**Re: Initial Submission Review Comment Responses – The Overlook at Kings Point South – Zoning Map
Amendment and Master Plan**

Application Number: DA-1628-08

Case Numbers: 2023-2004-00, 2023-2003-00

Overlook at King's Point Context Map

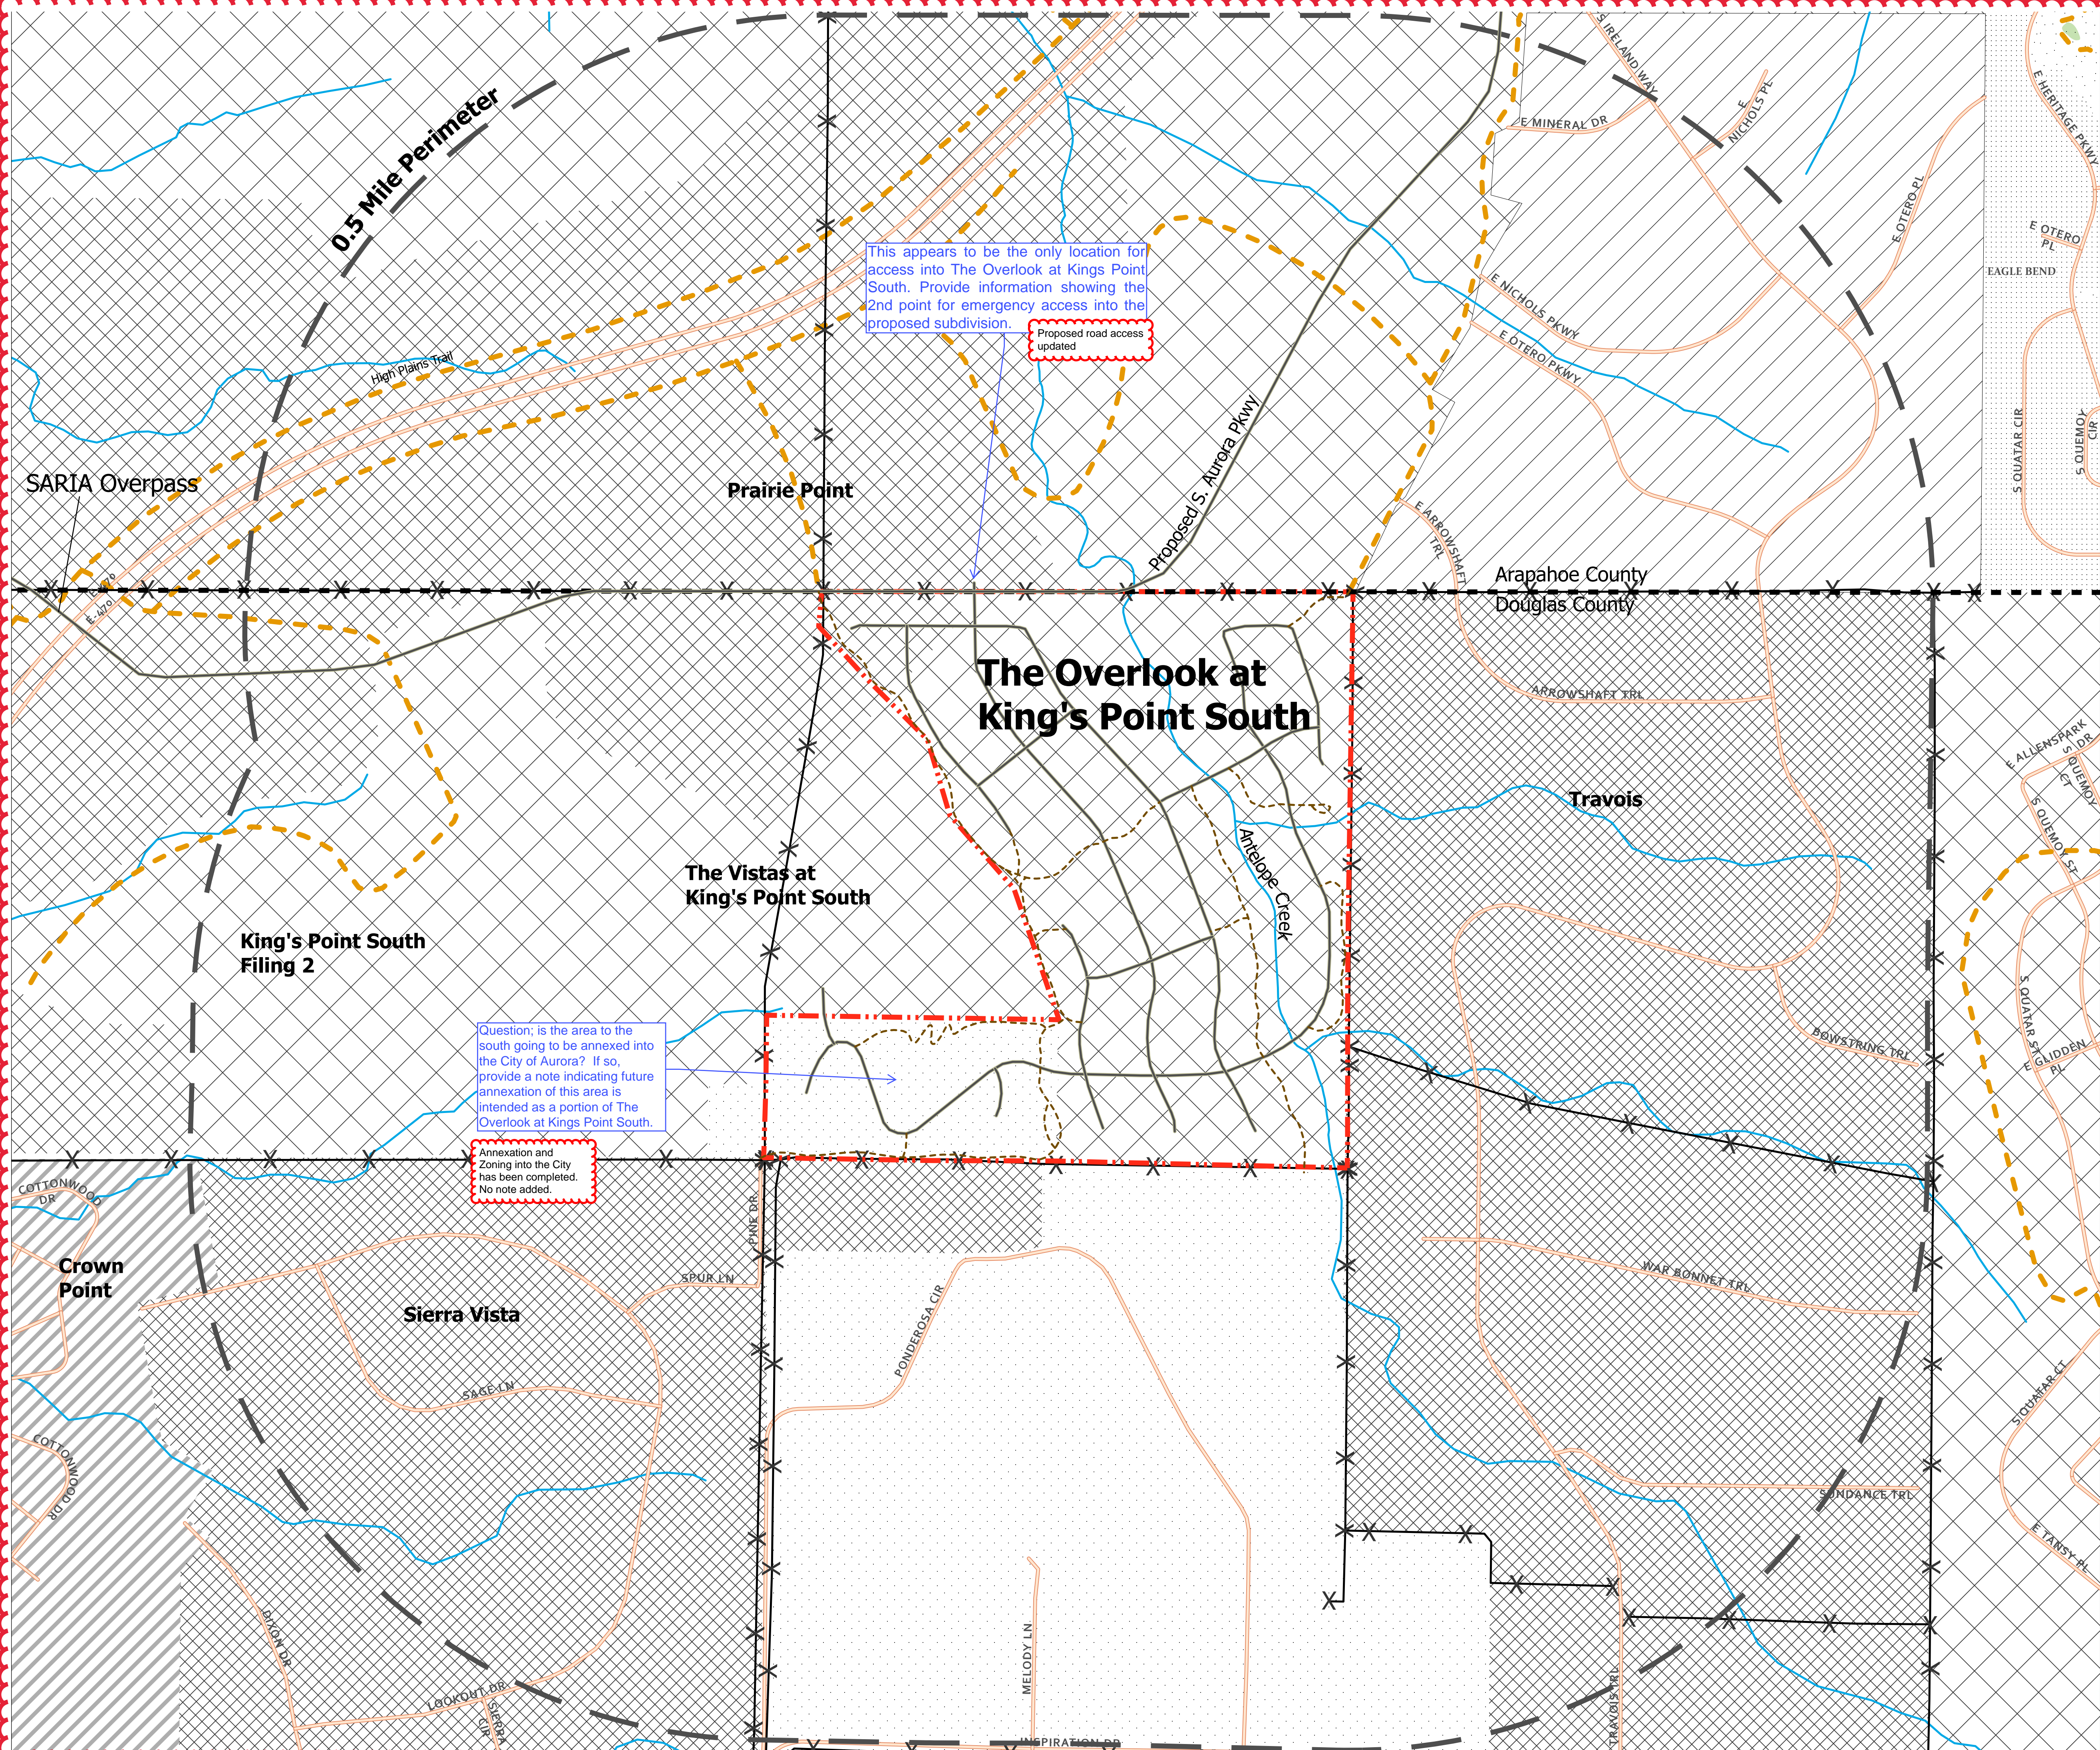
- Existing Streets
 - Proposed Streets
 - Existing Trails
 - Proposed Trails
 - Streams/Drainage Ways
 - Overhead Power Lines
 - Low-Density Single-Family Residential District
 - Medium-Density Residential District
 - Parks and Open Space District
 - Agricultural One
 - Incorporated Areas
 - Rural Residential
 - 0.5 Mile Radius
 - Rural Residential B
 - Planned Development
 - County Boundary
 - Project Site Boundary
- These two are too close, please change one. Updated

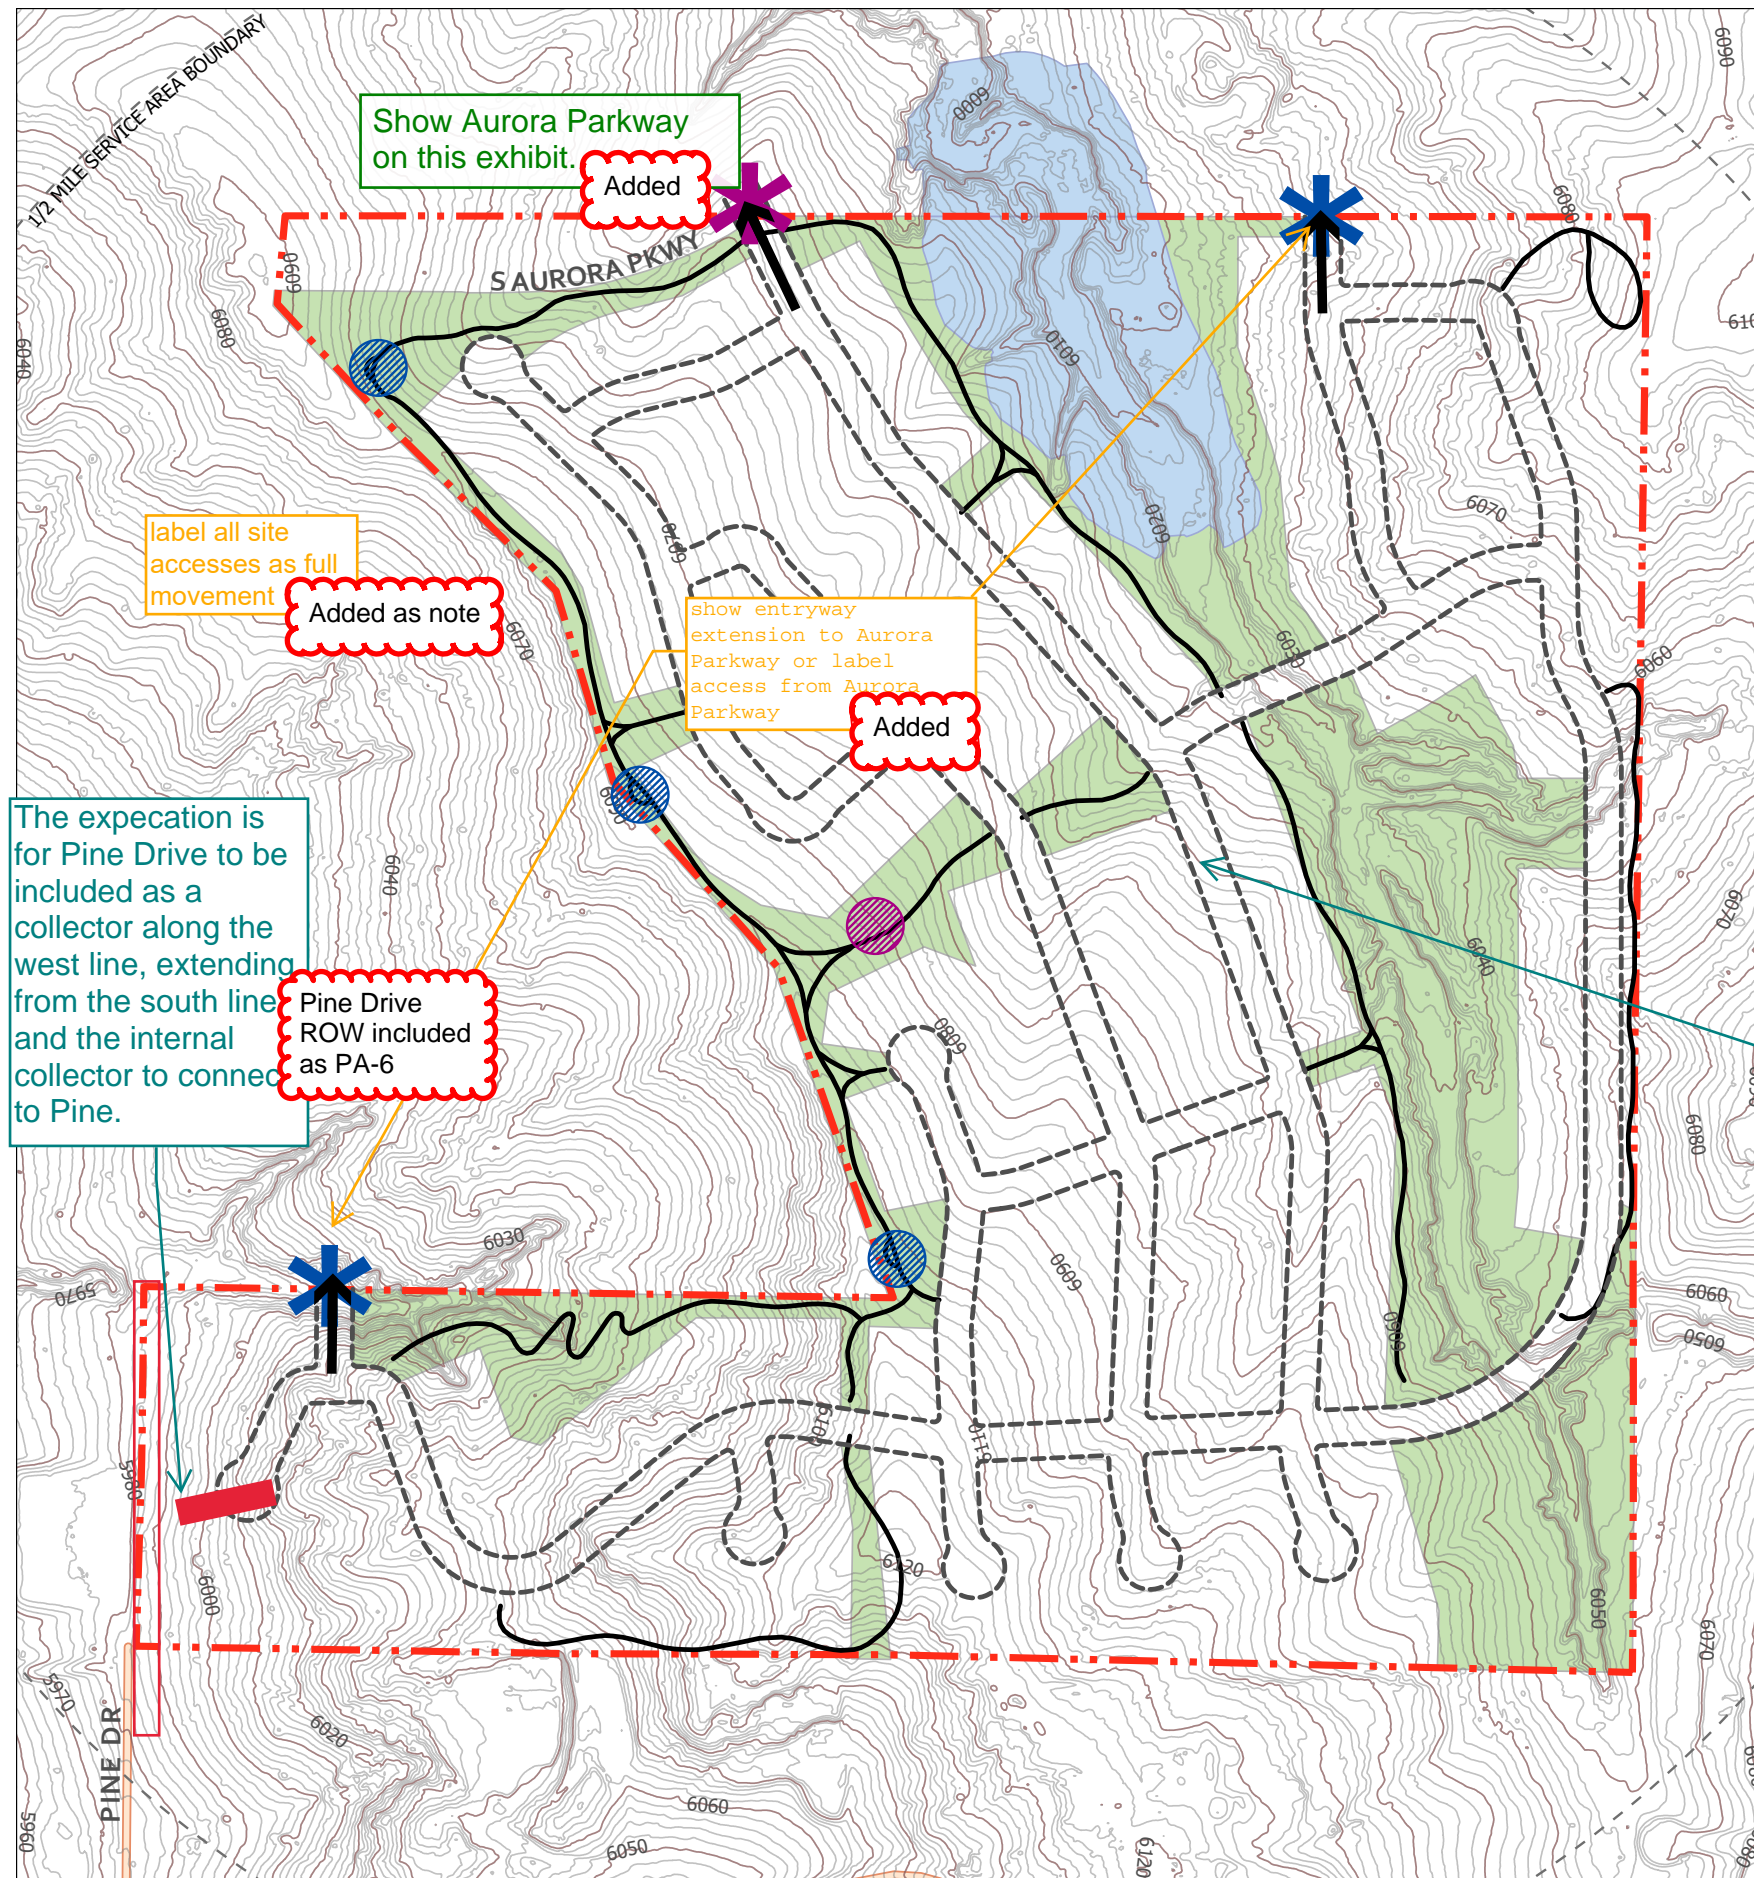
Add "conflict"

Add "the"

Added

Overlook at King's Point Context Map

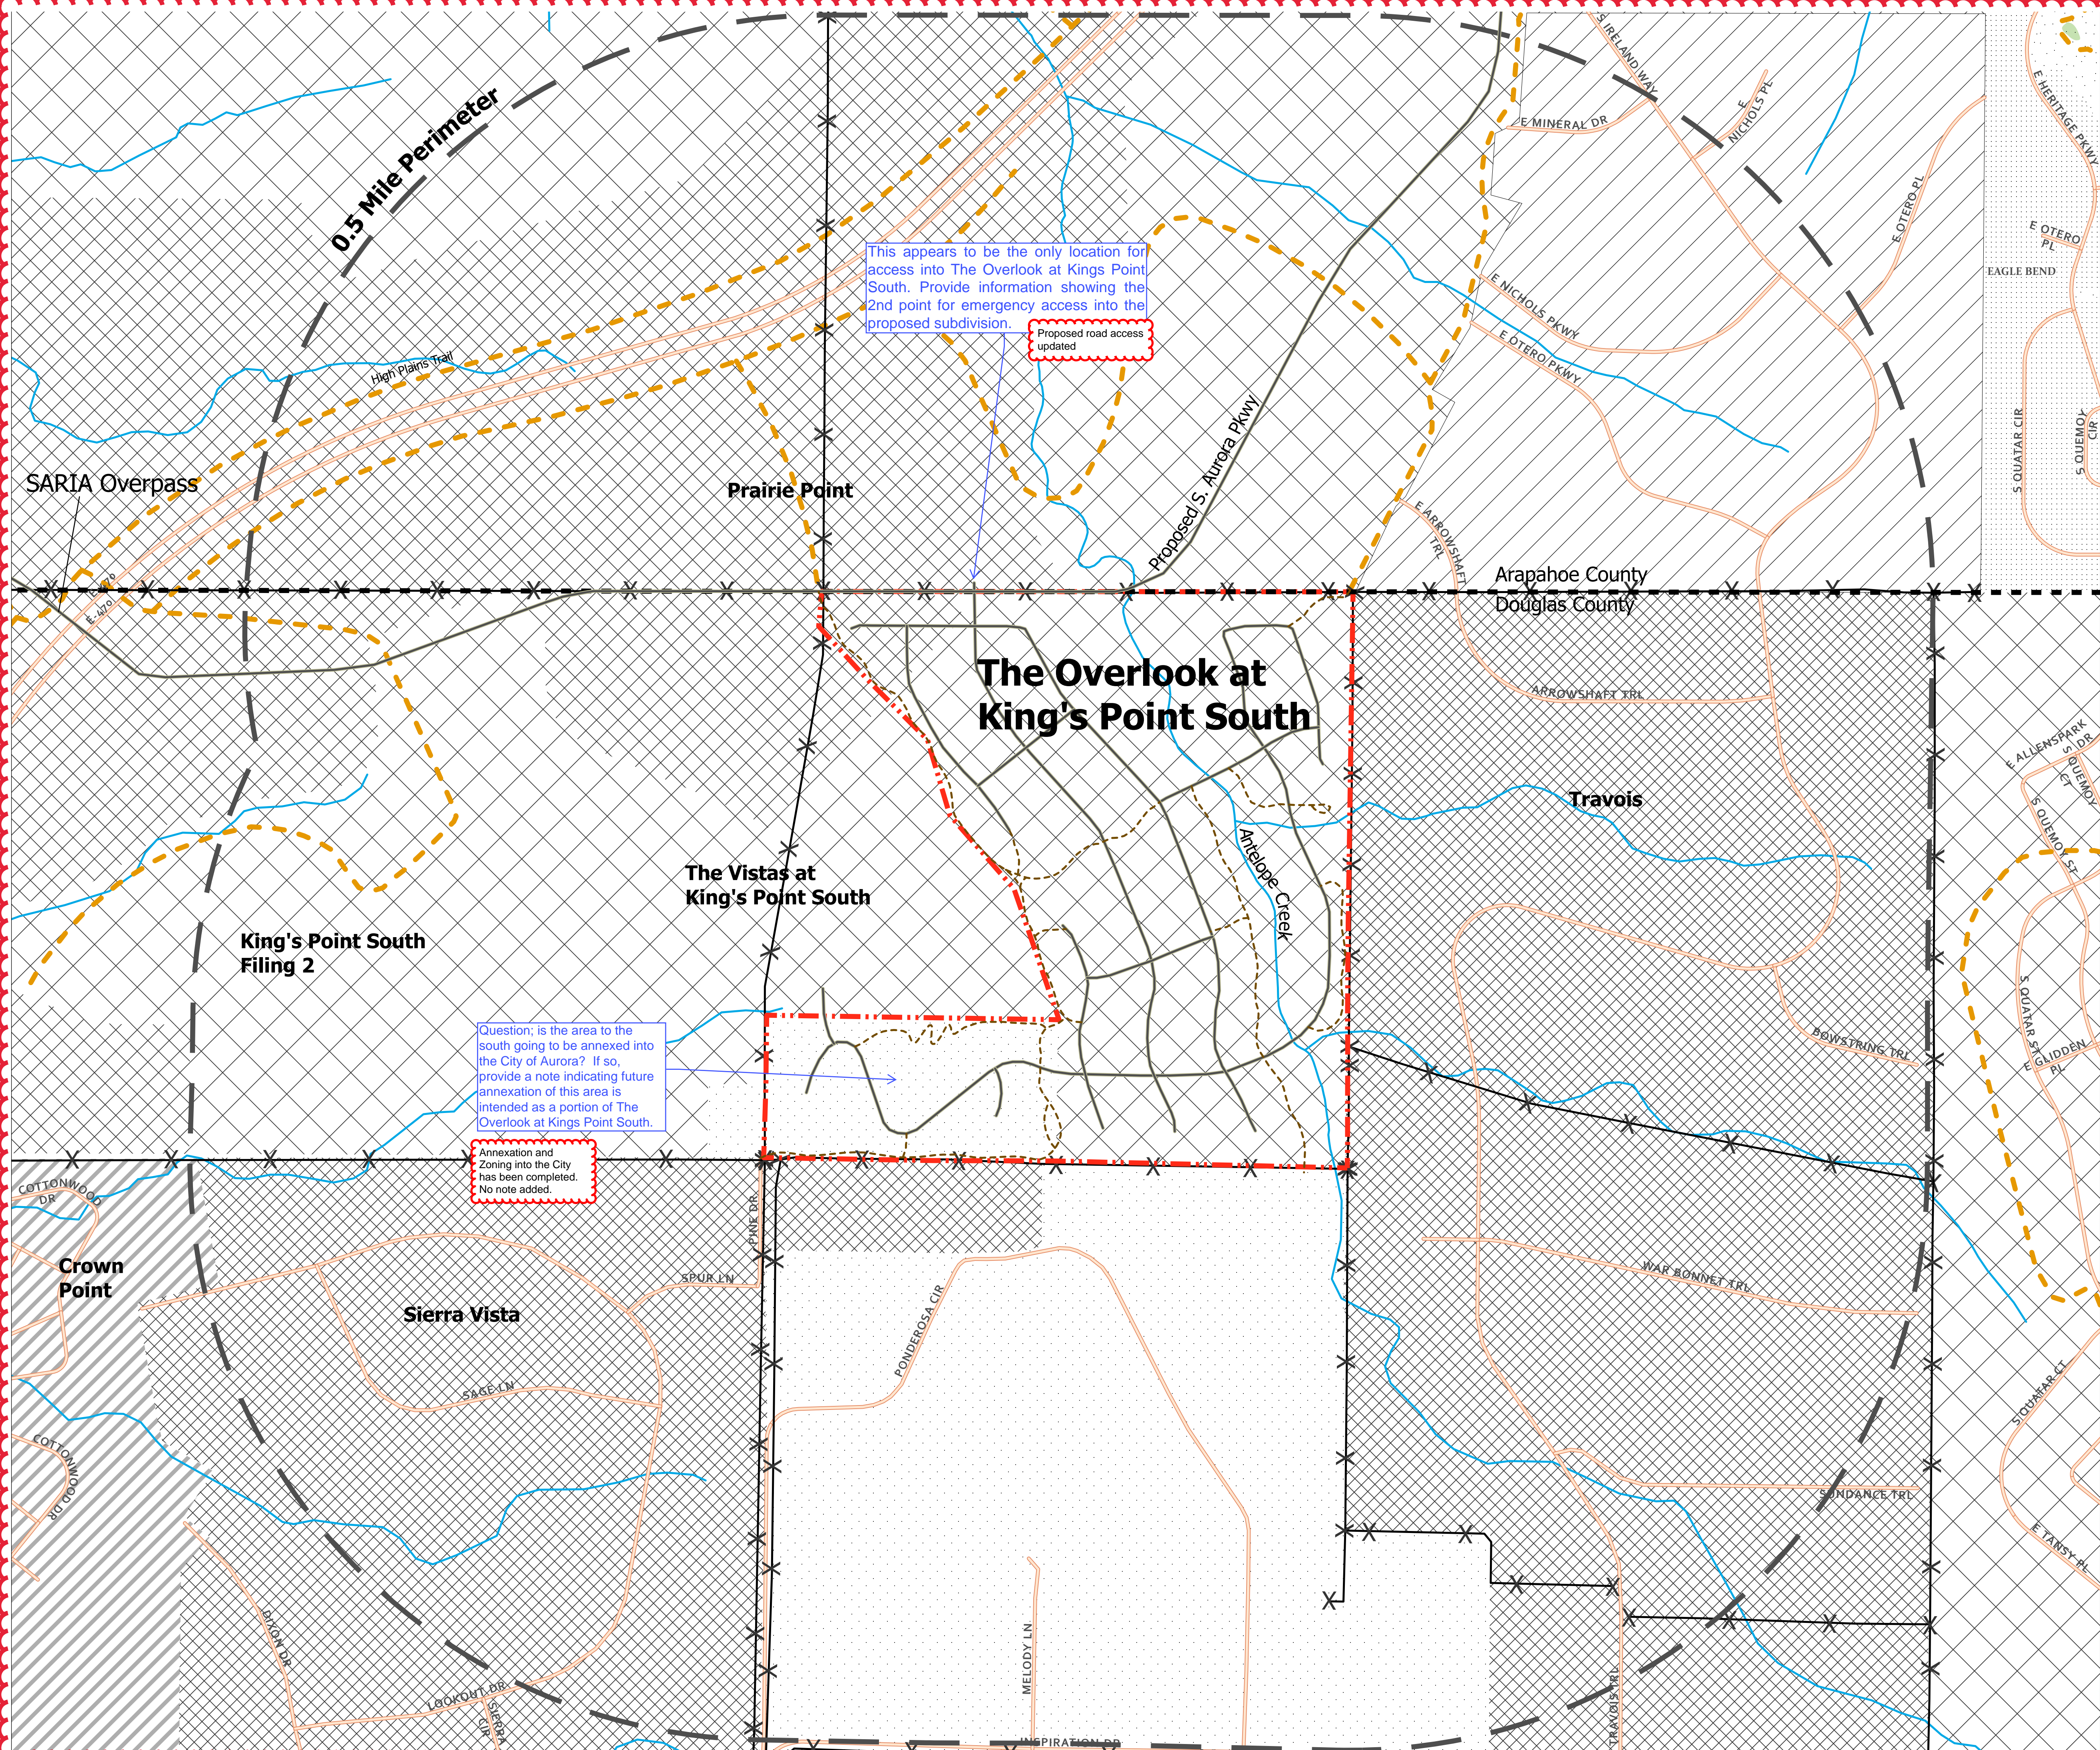
- Existing Streets
 - Proposed Streets
 - Existing Trails
 - Proposed Trails
 - Streams/Drainage Ways
 - Overhead Power Lines
 - Low-Density Single-Family Residential District
 - Medium-Density Residential District
 - Parks and Open Space District
 - Agricultural One
 - Incorporated Areas
 - Rural Residential
 - 0.5 Mile Radius
 - Rural Residential B
 - Planned Development
 - County Boundary
 - Project Site Boundary
- These two are too close, please change one. Updated
